Wessex Light Aeroplane Co. Ltd.

SERVICE BULLETON

TITLE: Correct Routing of Seat Belt Lap Straps.

No: WLACSB-H01.

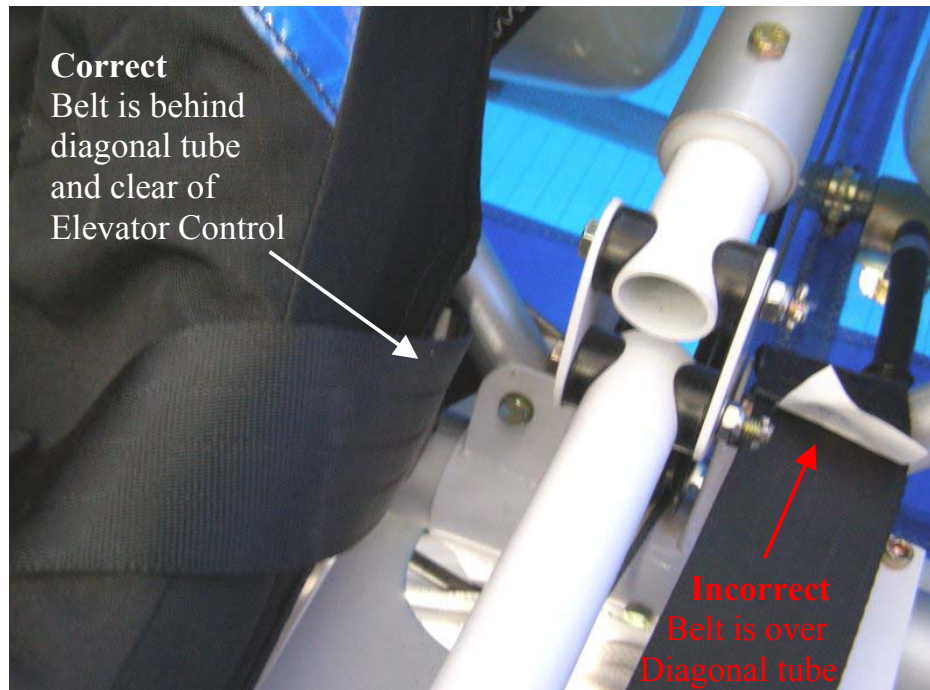
Correct routing of the Seat Belt Lap Straps is important to prevent fowling of the elevator control system.

Belts should be routed behind the seat back diagonal tubes 339050 as shown below and not over the top close to the pulleys.

Some aircraft may have also incorporated a strap to the side of the seat which also helps to keep belts away from control system, so long as routing of the belt complies to this service bulletin.
